REPORT OF THE CHIEF OFFICER PLANNING AND ECONOMY – 5 FEBRUARY 2024

APPLICATION NO:
P/2021 /0077

LOCATION:
CAE MOR FARM LLWYN MAWR
PONTFADOG LLANGOLLEN
WREXHAM
LL20 7BE

DESCRIPTION:
CODI UNED CYNHYRCHU EGG AM
DDIM ORGANIC A PHOB GWAITH
CYSYLLTIEDIG / ERECTION OF AN
ORGANIC FREE RANGE EGG
PRODUCTION UNIT AND ALL
ASSOCIATED WORKS

Location Plan

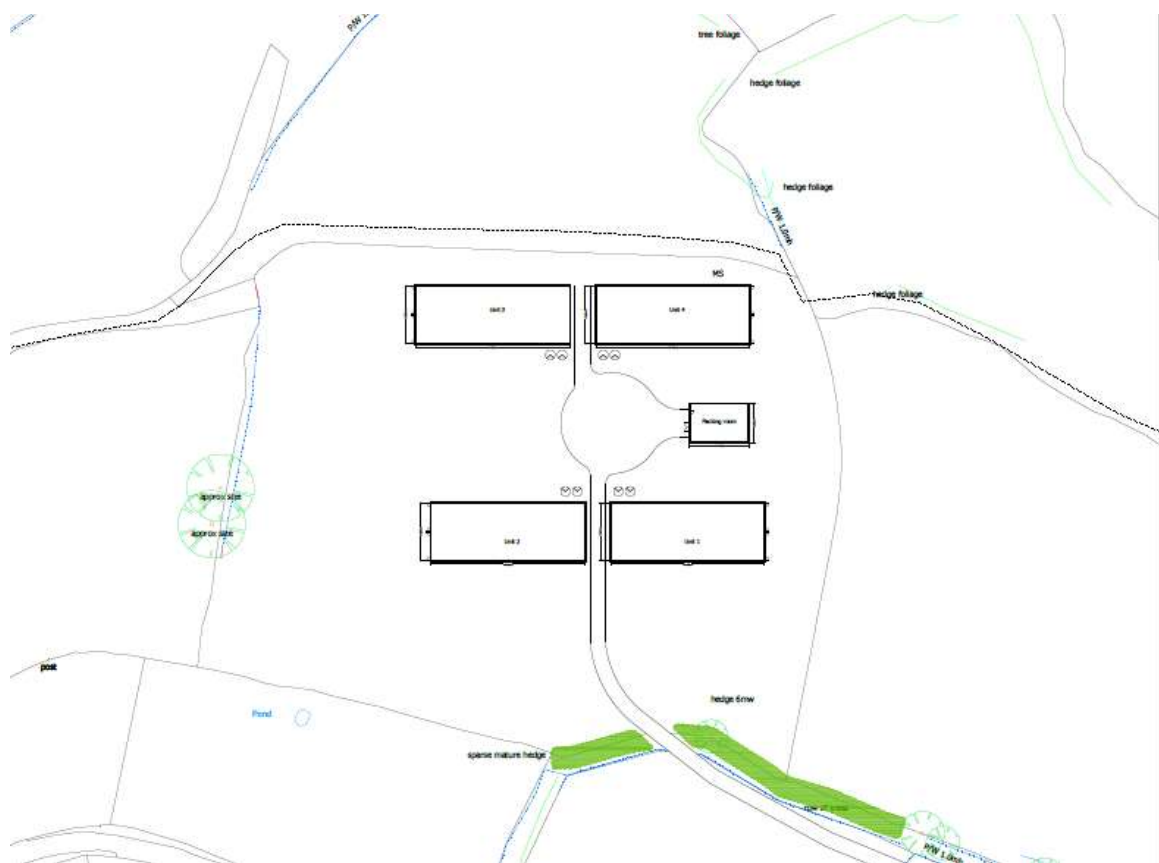
7. Document 4767668: Location Plan
This plan along with all of the other plans (with the exception of Document 4767665) and drawings, whilst it includes Cae Mor Farm and other buildings does not include any reference to Cae Mor 1 so no comparative assessment on size, proximity or aggregate impact is possible.

13. Document 4767645 Location plan
The location plan does not show the position of Cae Mor 1. The inclusion of this would have given some comparative indication of the size of the new proposal.

Proposed Elevations and floor plan – Packing Room

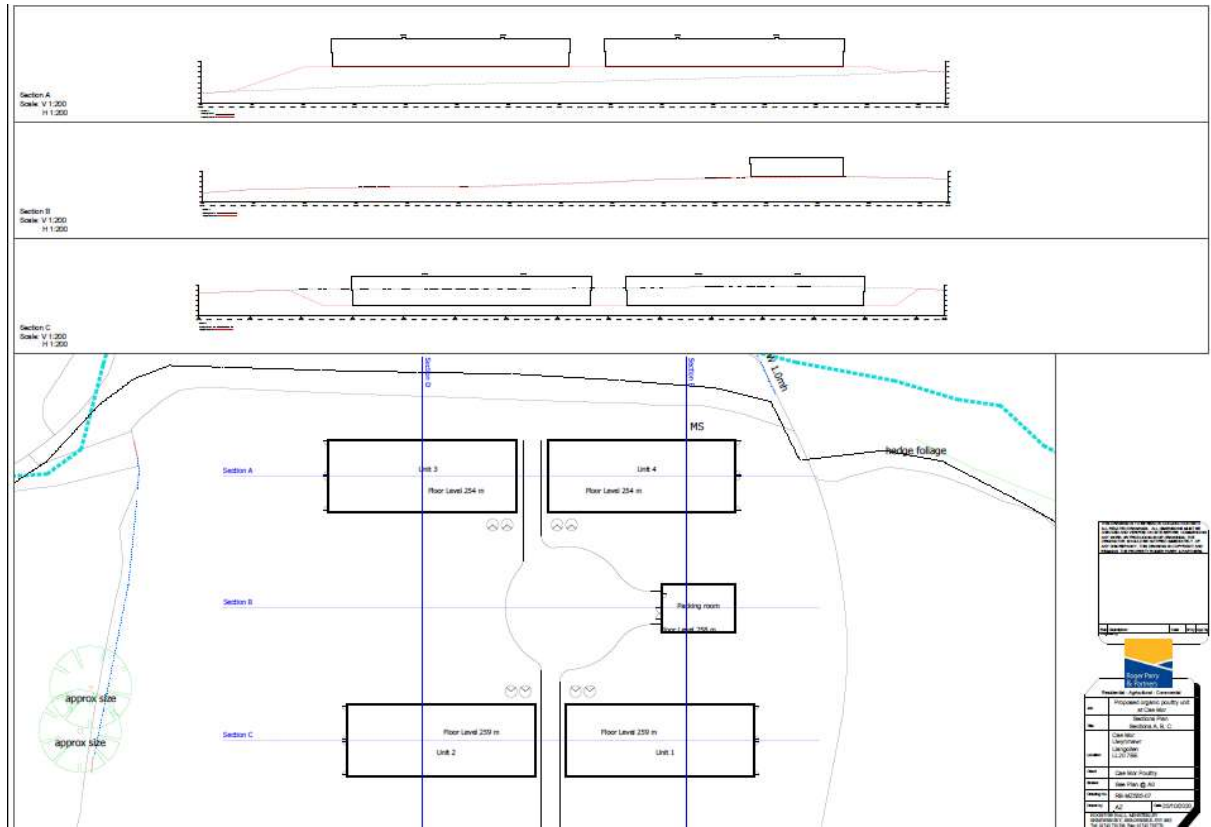
The drawings do not show the position or aspect of the elevator or other equipment which, in Cae Mor 1 is the tallest and most prominent part of the structure.

Proposed sections East-West

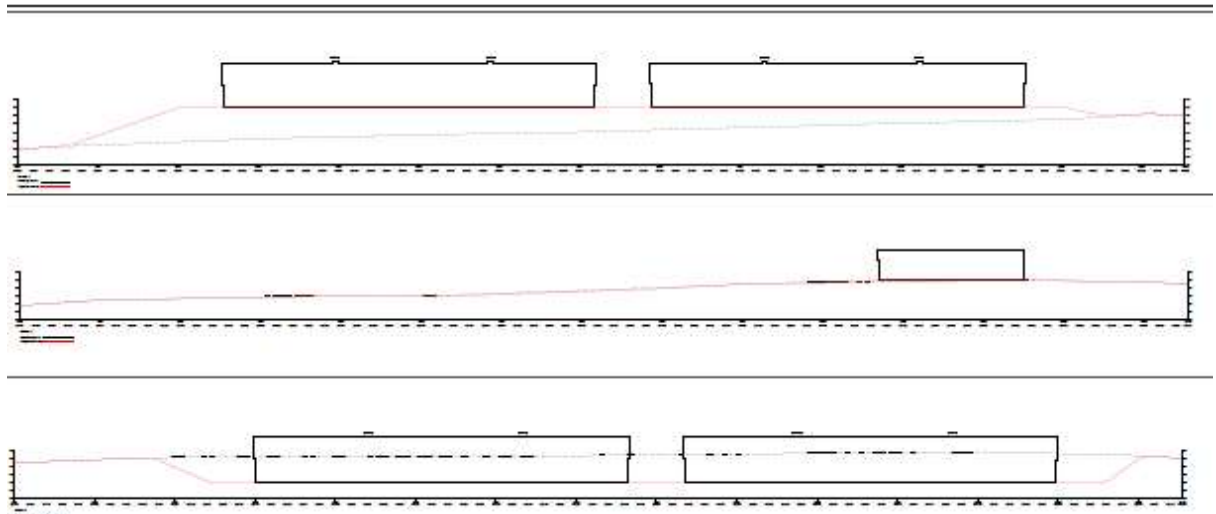
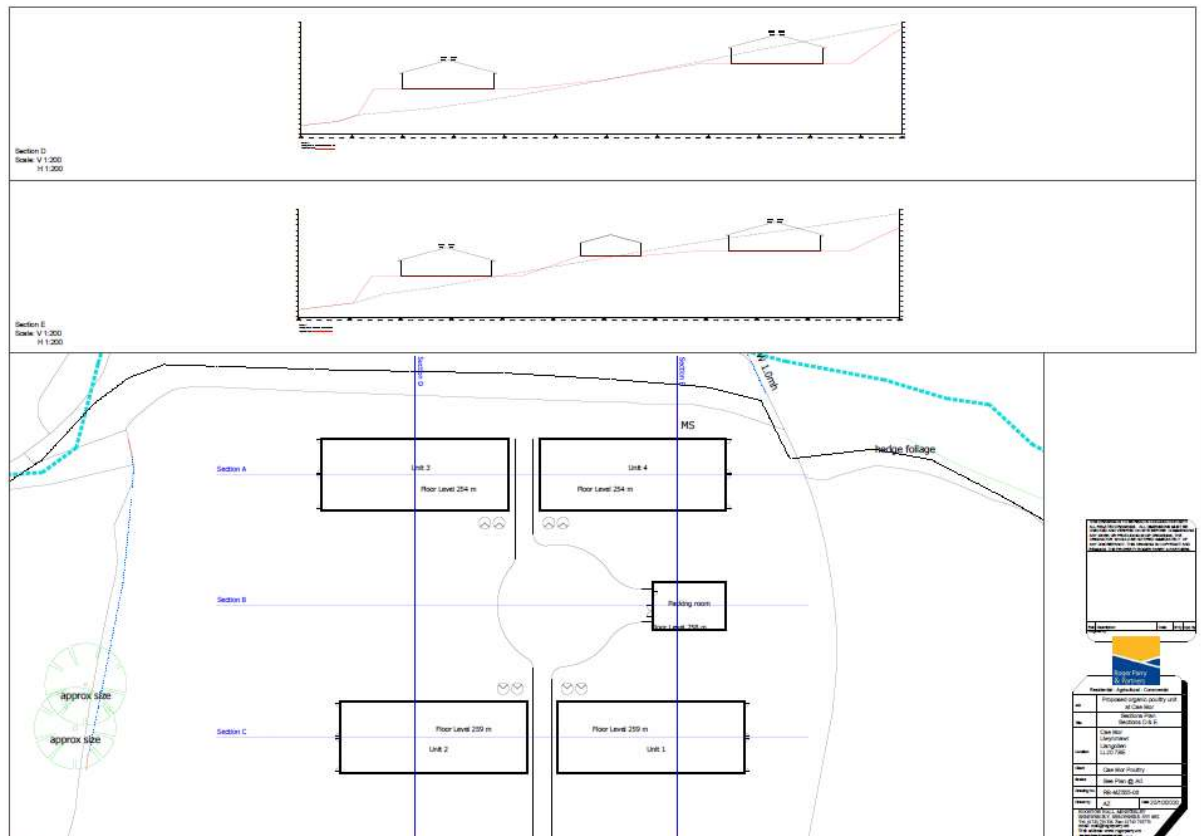
11. Document 4767652 Proposed Sections D and E would seem to indicate that the northern most of the buildings would be built on outcrops making them exceedingly difficult to screen from a northern viewpoint. This needs clarifying as the narrative here and elsewhere identifies landscape and vegetation screening.

Drainage scheme

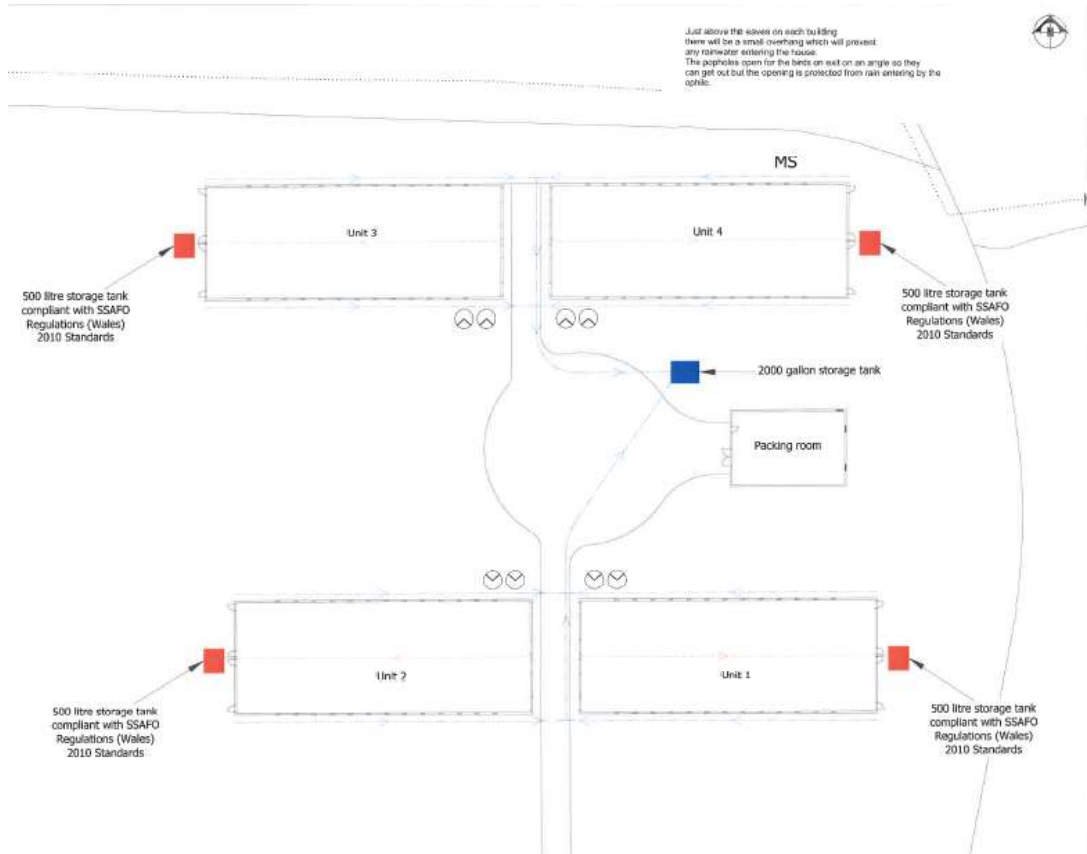
8. Document 4767666: Drainage plan
The drainage plan deals with water from the wash down process and the clean water from the roof surfaces but does not consider the run-off from all hard standing or ranging areas (which includes the hard standing). It is this run-off that will contain manure contaminants.

The “fresh” water tank is 2000 Gallon whereas the foul storage are only 500 litres. If the first is used in the washdown process to fill the latter, this is inconsistent.

The drainage plan (drawing no. RB-MZ555-06) shows the clean and dirty water being drained separately. The dirty water will be drained to an underground tank built to comply with the SSAFO standards. The drainage plan must be included in the 'approved list of plans / documents' condition within the decision notice should consent for the project be granted.
